# Level 1 Floorplan

#### Modifications

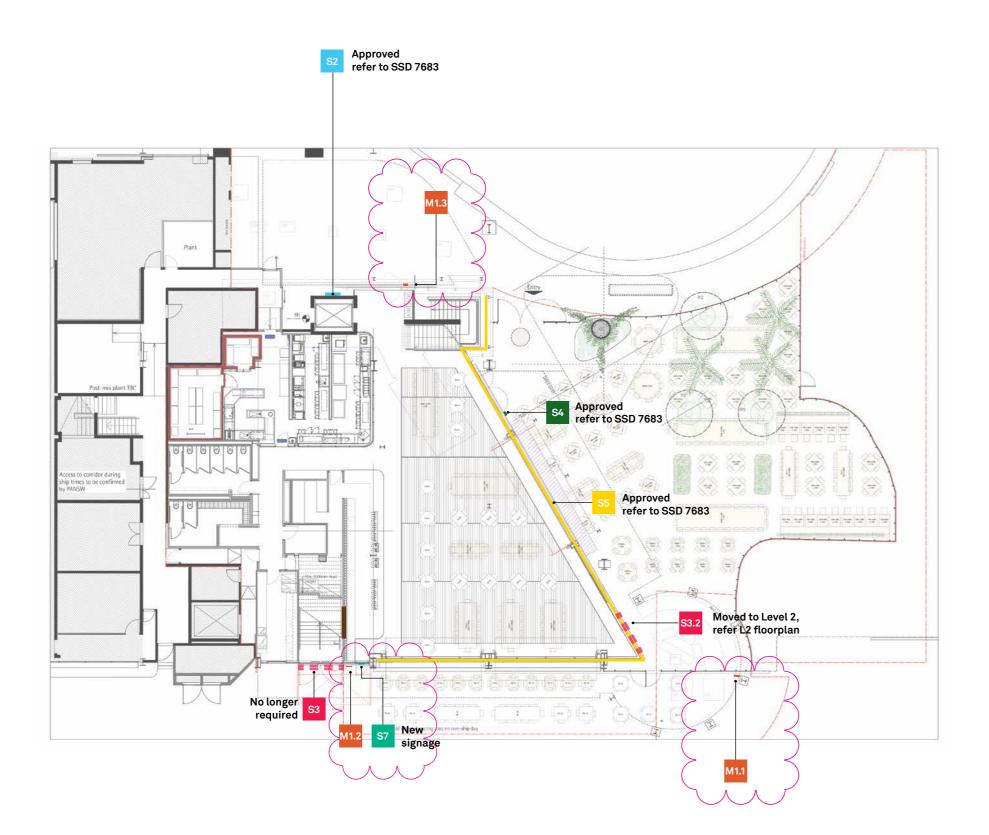
- The Squire's Landing logo window vinyl

Non-illuminated ground floor external door.

New vinyl signage as this door is being used by customers a an entry point
- S3.2 James Squire Signature + Cross Shovels identification moved to Level 2, refer L2 floorplan
- M1.1 to M1.3

Five new menu stands see construction below

## **East elevation**

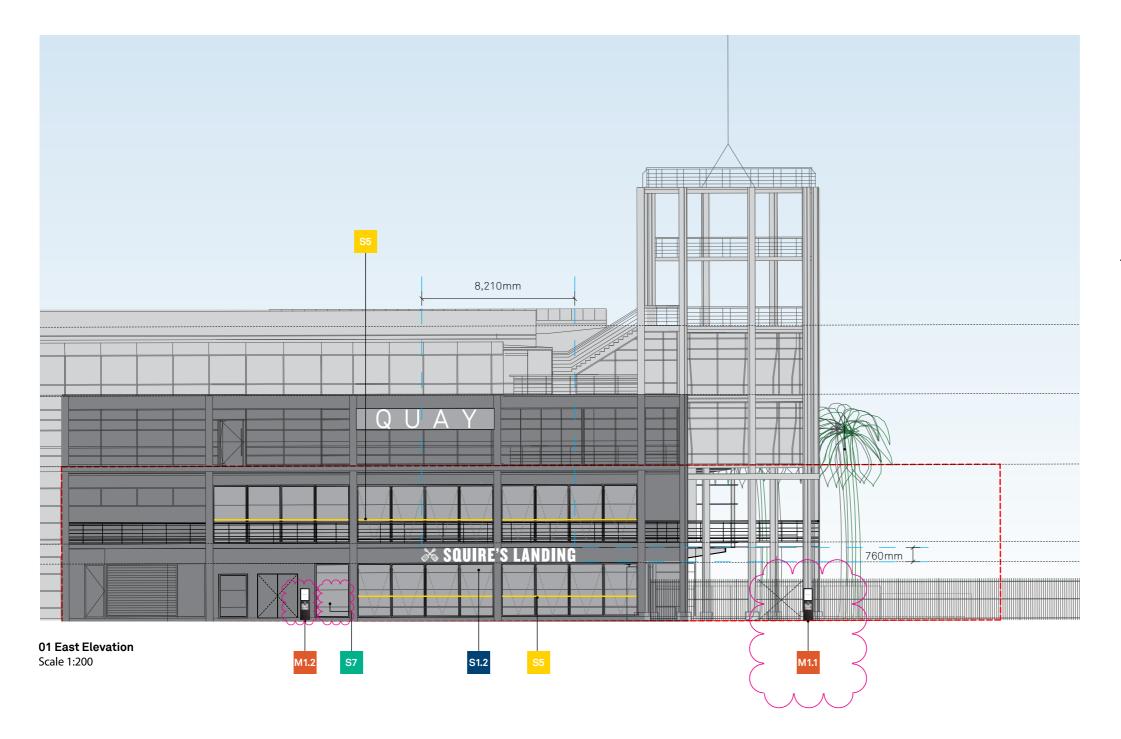
Non-illuminated – ground floor external door.

New vinyl signage – as this door is being used by customers a an entry point

## **West Elevation**

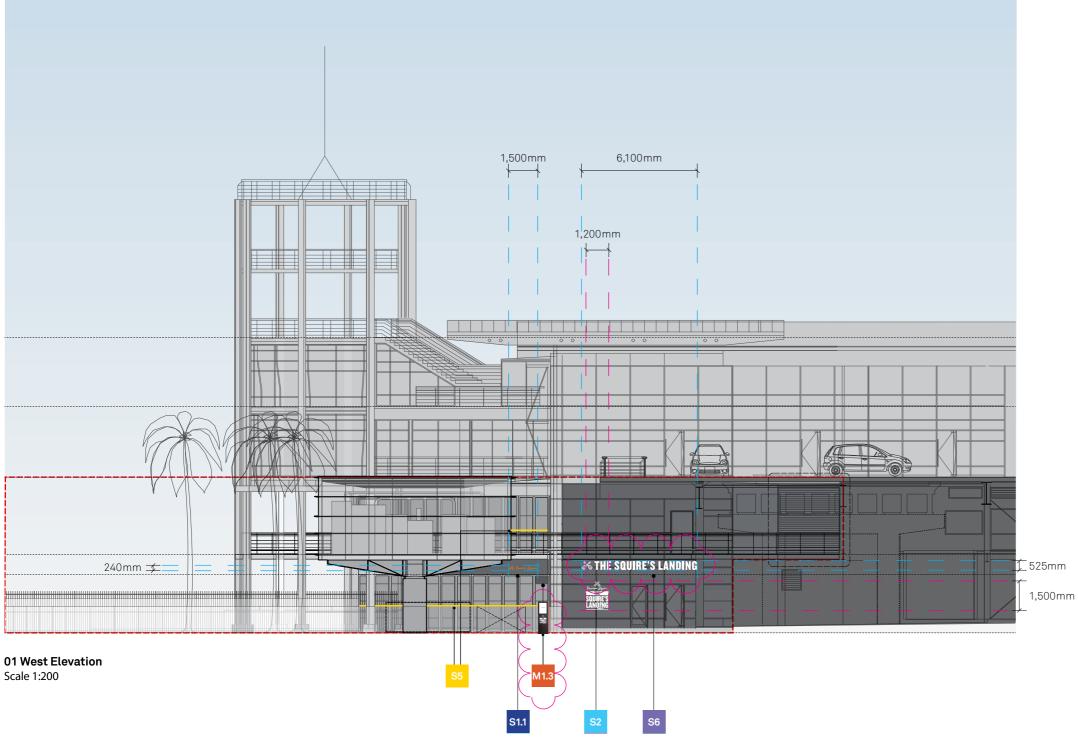
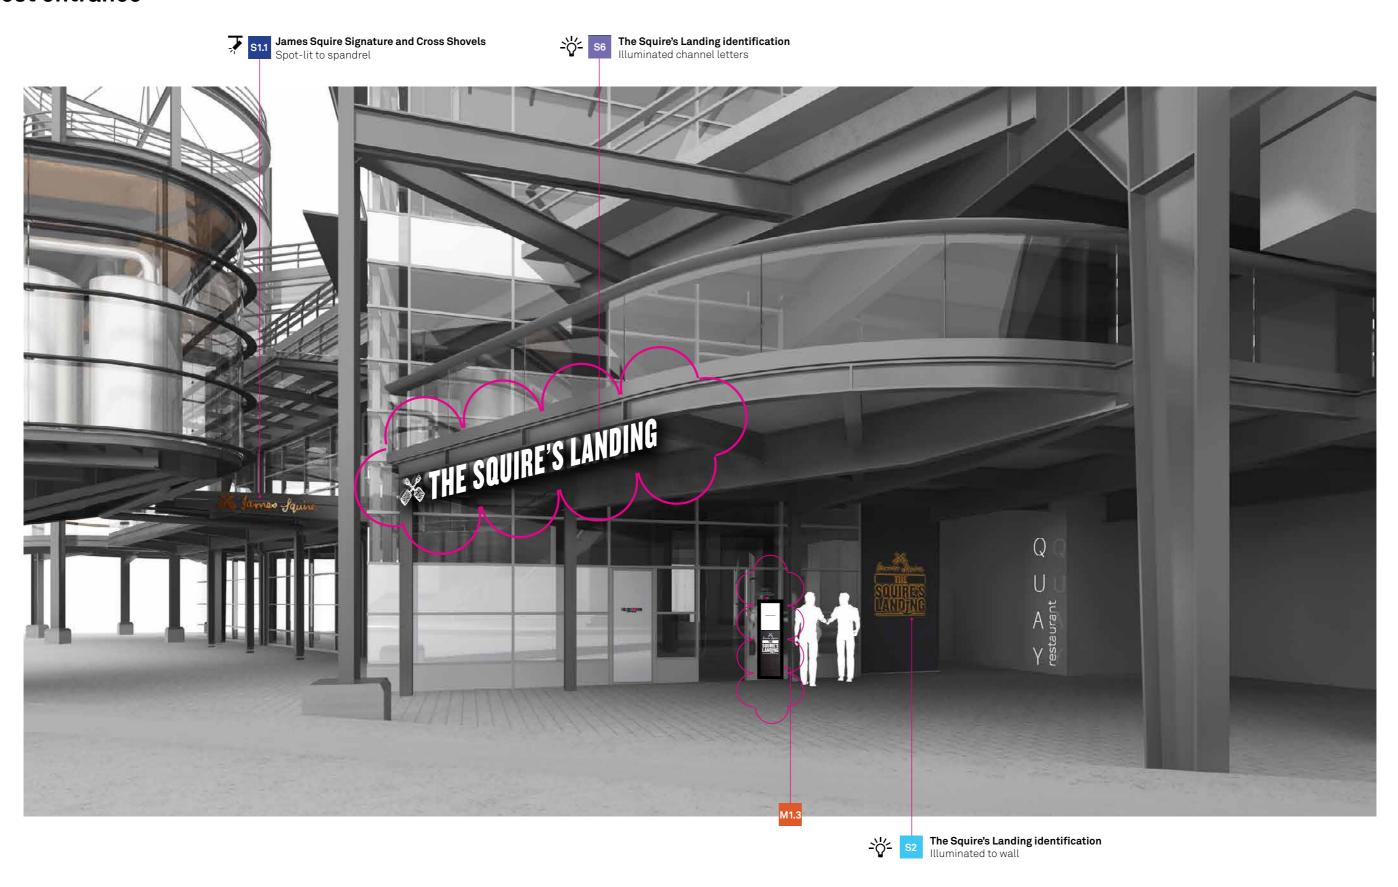
The Squire's Landing identification New sign Level 2 balcony. Sign is illuminated.

## North elevation

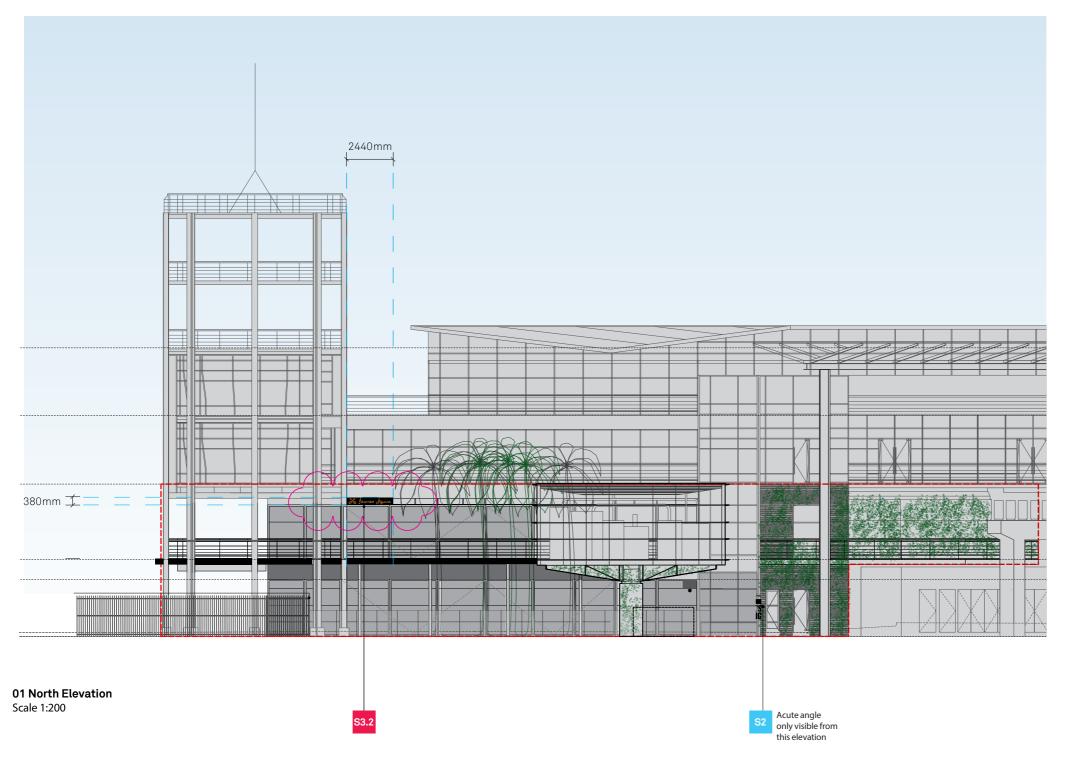
James Squire Signature + Cross Shovels identification
S3.2: relocation from ground floor low level building spandrel

to Level 2 awning beam. Size increases from 1285 x 220mm to 2440x380mm. Sign now halo lit.
